REPORT AMENDED BY CPC 5-22-86  
**CI PLANNING COMMISSION**

**LOCATION:** 800 El Camino Avenue, 2472 Beaumont Avenue

**PROPOSAL:** The applicant is requesting the necessary entitlements to locate 14 required parking spaces off-site.

**APPLC. NO.** P86-148 **MEETING DATE** May 22, 1986 **ITEM NO** 13

# SITE PLAN

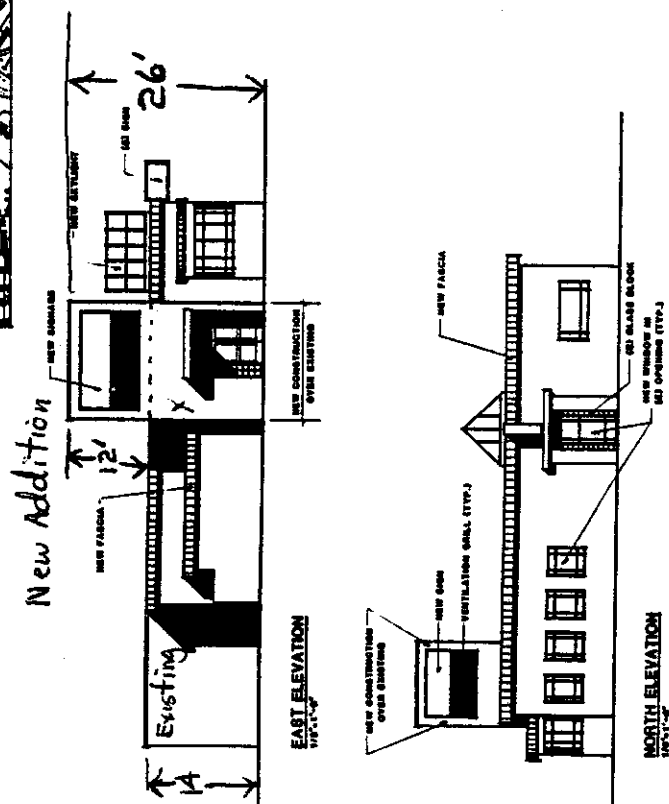
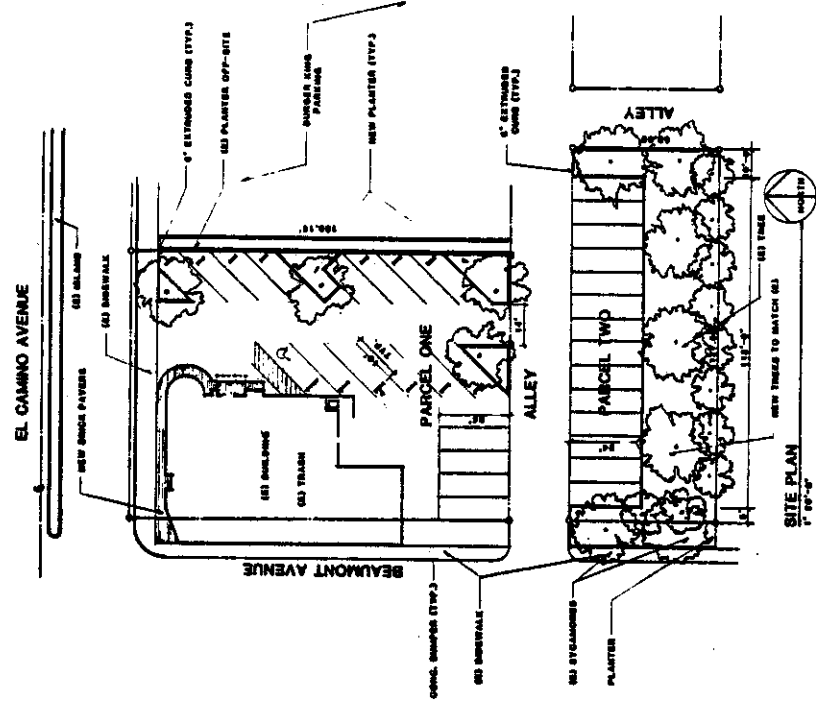
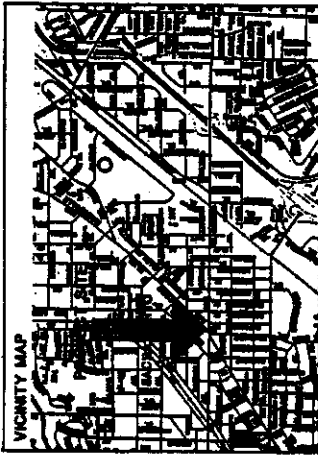
1. The 45<sup>o</sup> parking adjacent to the Burger King property line on the east should be reoriented to 90<sup>o</sup> parking with the two northernmost stalls designed to compact car stall size. A four foot planter with tree is recommended along the El Camino Avenue frontage on the north. A four foot planter with tree is recommended at the southern end of the 14 parking spaces adjacent to the alley.

2. The applicant should investigate the option of expanding the Burger King planter strip so that two feet of vehicle overhang onto the planter on the subject property can occur. If not possible, concrete wheel stops shall be required.

3. The City Traffic Engineer and Zoning Ordinance require a 26 foot backout maneuvering area for 90<sup>o</sup> parking. A two-way driveway on the east side of the restaurant should be 24 feet in width as a minimum at the El Camino Avenue curb edge.

4. The handicap stall and trash enclosure shall be relocated to the satisfaction of the City Building Division and Planning Division. The trash enclosure shall comply with the Trash Enclosure Guidelines (Exhibit A).

5. The City Traffic Engineer indicated a need to show a 10 foot radius for entrance to the driveway from the alley into the restaurant parcel.
6. The recommended changes to Parcel 1, the restaurant site, is intended to provide easy access from both El Camino Avenue and the alley to all parking spaces. By providing ease in parking, Parcel 1 should be filled before the off-site parking lot is used.

- a. Extend planter along El Camino Avenue property line
- b. Define driveway on El Camino Avenue
- c. Two-way driveway must be at least 20 foot aisleway - 24 foot street opening
- d. Dedicate 10 foot radius at alley way for Parcel 2
- e. Need 10 foot radius for entrance to driveway from alley into Parcel 1

- 3. The applicant shall modify the site plan for Parcel 1, the restaurant, as shown in the Staff Modified Site Plan prior to issuance of building permits for the restaurant.
